FIELD SERVICE BULLETIN

FSB Number: EICCFSB – 20
Author: Paul Convery
Date: 1st April 2003
Total No. Of Pages: 2
Subject: **9.6 kbps SIM card not compatible with C350**
Model Affected: C350
Level of Repair: 3/4

Fig1

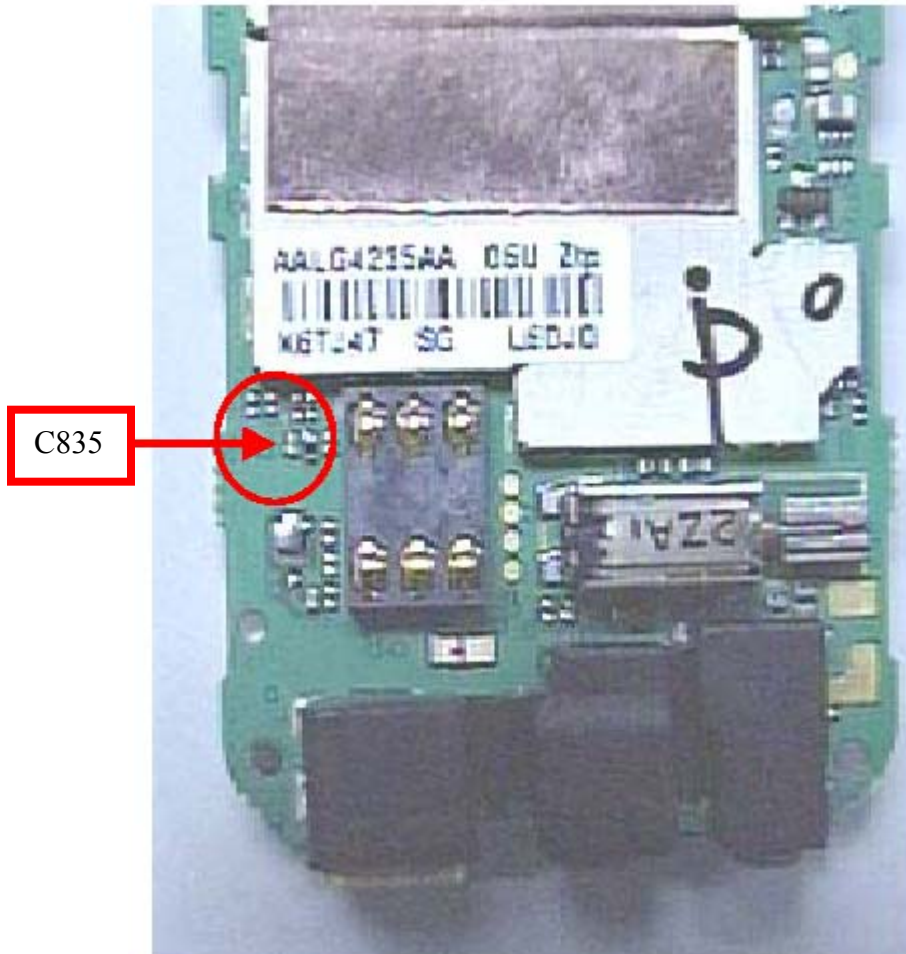
Any radio returned for repair with a customer complaint: Main Keypad No Function, Auto Power Down, and Check Card/ "Please Wait" should remove C835 from the main PCB. Please see fig 1 for details.

The Design group determined that by removing C835 ([Part No 2113743L17](#)) from the PCB, the issue would be resolved.

An ECP (No 133329) was implemented March 13th 2003 to delete C835 from the PCB.
